Tesla, Inc. Service Bulletin		<i>Replace RH Body Controller Module To Enable Third-Row Seat USB Power</i>	
SB-23-17-003 March 24, 2023			
Classification		Section/Group	Mobile Service
Repair Bulletin		17 - Electrical	Can Perform (where permitted)
Model Year	Model	Country/Region	Build Location
2023	Model Y	North America	Fremont
The model(s) and model year(s) listed are a general approximation of the affected VIN list. Refer to the VIN/Bulletin Tracker or Customer/Vehicle profile to determine applicability of this bulletin for a particular vehicle.

✗ Figure 1 – Connector X050 missing pin A32

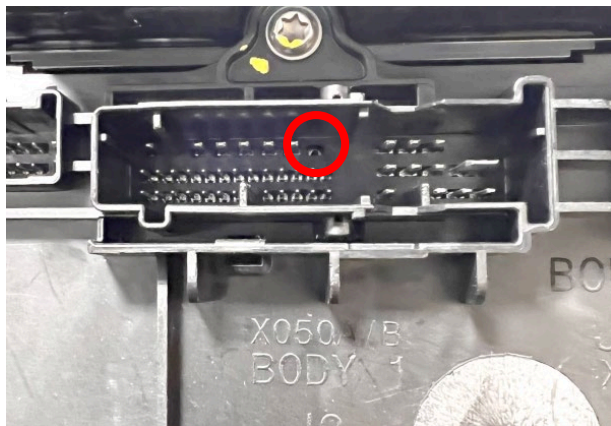
1. Remove the RH body controller module (refer to Service Manual procedure [17152202](#)).
2. Inspect the top center connector X050 of the replacement RH body controller module, and verify that it has a power pin at A32 (Figures 1 and 2).

NOTE: Do not install the new RH body controller module if pin A32 is missing.

3. Install the replacement RH body controller module (refer to Service Manual procedure [17152202](#)).
4. Verify that the third-row seat USB ports provide power.
